Paradise Ranch
Land Owners Association, Inc
P. O. Box 2426
Victoria, TX 77902

Re: Exelon's Victoria County, Texas Application

Figure 3.1-9 Total Land to be Developed

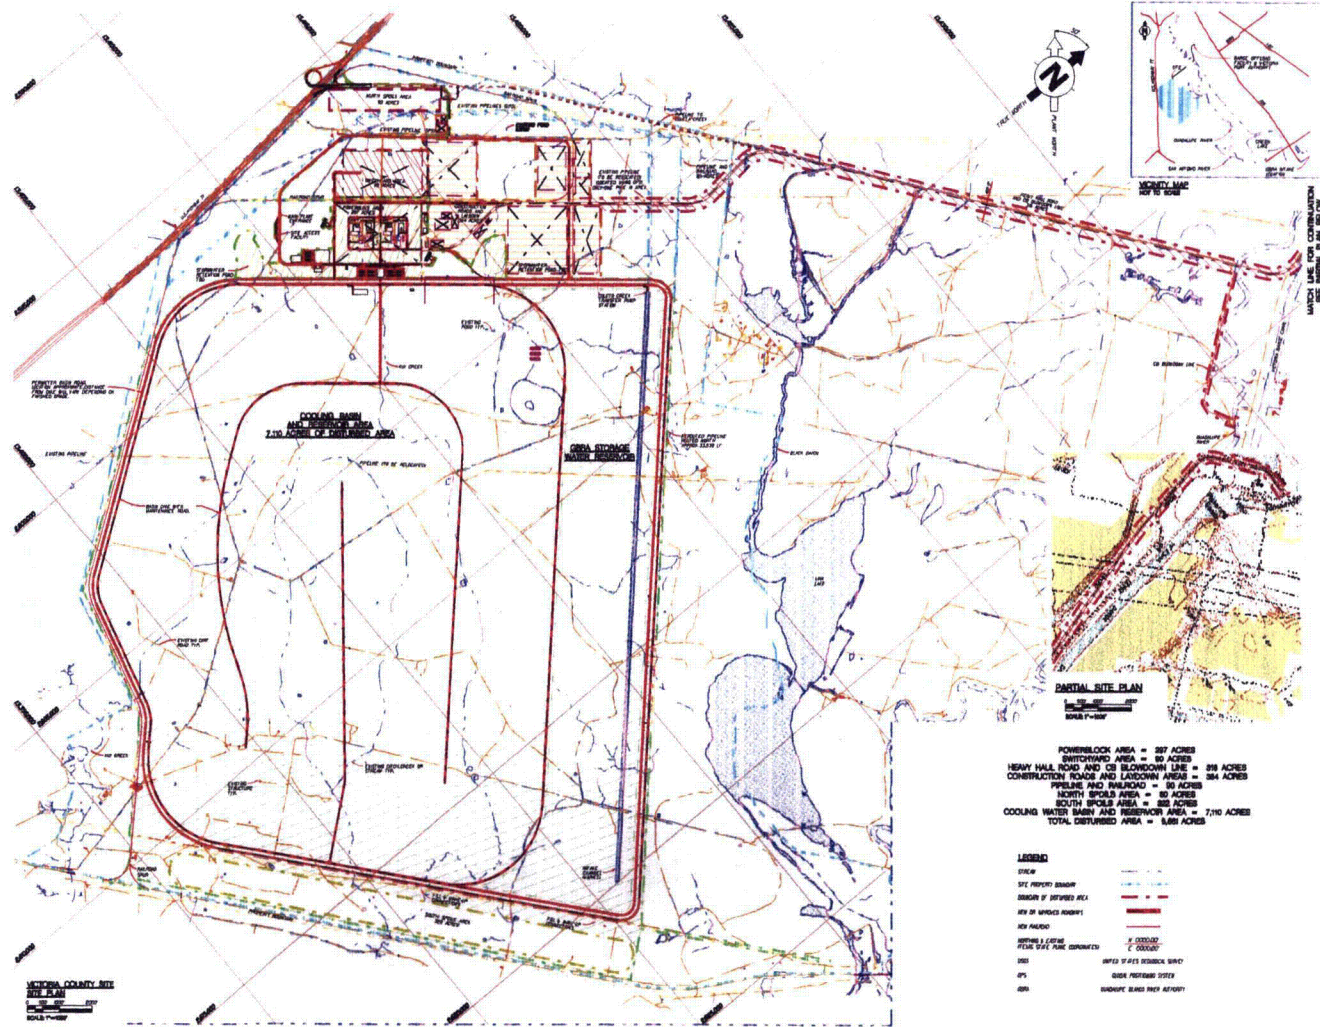
Exelon has also identified our property to have the majority of the Heavy Haul Road located across it. The proposed roadway is directly across our existing ingress and egress easement road from Hwy 77 South. In addition to our Ranch there are two other ranches known as the Gibbs and Stubblefeild ranches that also use the easement road. Exelon did

not address anything about our access in their application. We were told by Exelon representatives at our homeowners meeting that we would not be allowed to use the Heavy haul road for approximately 10 years. On any given day there are 25 to upwards of 200 people on the three ranches. We have included a map from Chapter 3 of the permit application with our notations so that you may better understand our positions and concerns.
